July 24, 2024

**Subject: Objective Design Standards (ODS) for 4–8 story residential and mixed use multifamily buildings– Oakland Heritage Alliance (OHA) preliminary comments—Item 1 on DRC’s 7-24-24 agenda**

The attached marked-up pages from the draft ODS and the following comments supplement the comments in our 7/24/24 letter package to the City Planning Commission’s Design Review Committee (DRC):

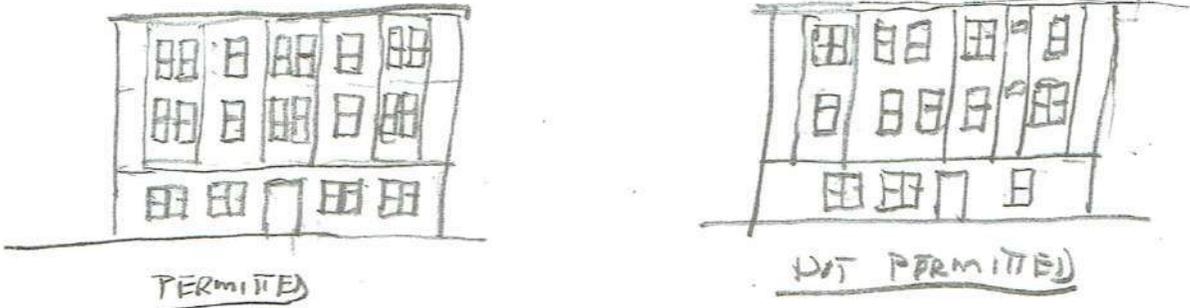
- (i) *Arrange ...the tops of doors and windows in horizontal alignments.*
- (ii) *Use consistent shapes and dimensions.*
- (iii) *For at least two-thirds of the windows on each floor on each elevation except for ground-floor non-residential space:*

- (a) *horizontally align the bottoms of the windows; and*
- (b) *provide window heights of at least 4 feet or 50% of the floor-to ceiling height (whichever is greater).*

(iv) *Do not use random fenestration patterns.*

- (ii) Use consistent shapes and dimensions;
- (iii) For at least two-thirds of the windows on each floor on each elevation except for ground-floor non-residential space: (a) horizontally align the bottoms of the windows; and (b) provide window heights of at least 4 feet or 50% of the floor-to-ceiling height (whichever is greater);

- (iv) Do not use random fenestration patterns;

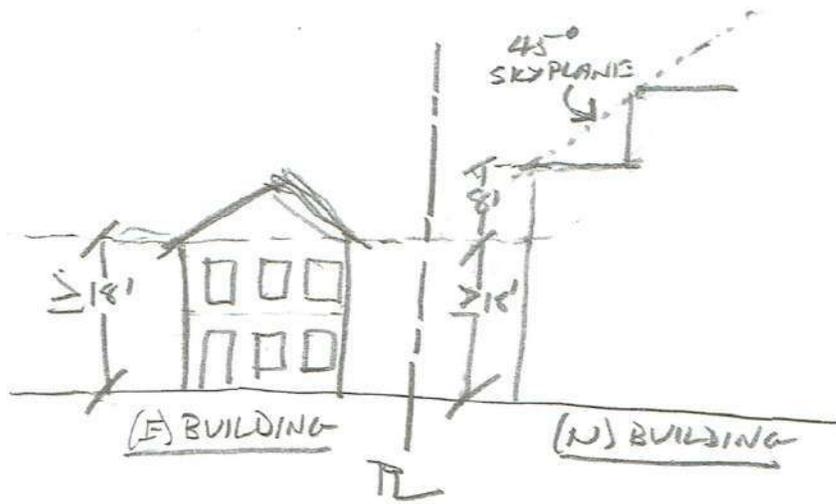
b. *Do not set back portions of floors below cantilevered upper floors or roofs without corner columns. Any such setbacks shall not exceed one story.*

G. Do not set back portions of floors below cantilevered upper floors or roofs at building corners without corner columns. Any such setbacks shall not exceed one story.

**WOOD DOUBLE HUNG SASH**  
Typical Dimensions

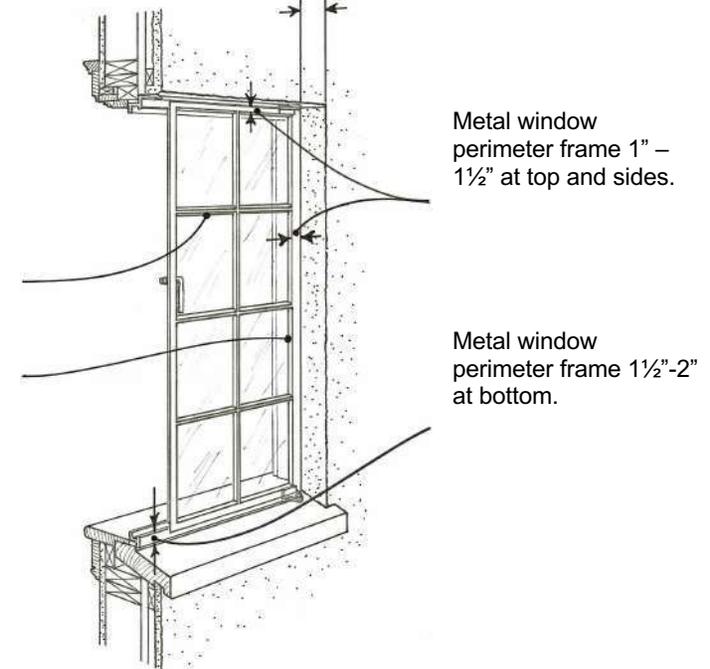
However, we recommend that the text be modified to emphasize that windows of *any* material (such as fiberglass) can be used that visually match the wood or (for some buildings usually constructed after circa 1920) steel windows characteristic of API and ASI contributing buildings. In addition, can this provision be expanded to ASIs?

2. **Provide more complete window standards.** This reiterates Item 7 in our 7/24/24 letter, including using Exhibit D to our 4/30/21 letter as a starting point, especially Exhibit D Figure 1. In particular, the ODS should incorporate the following Exhibit D provisions concerning divided light windows:

- ¾" min.--wood or simulated wood siding
- 1" min.--cement plaster
- 3½" min.--masonry
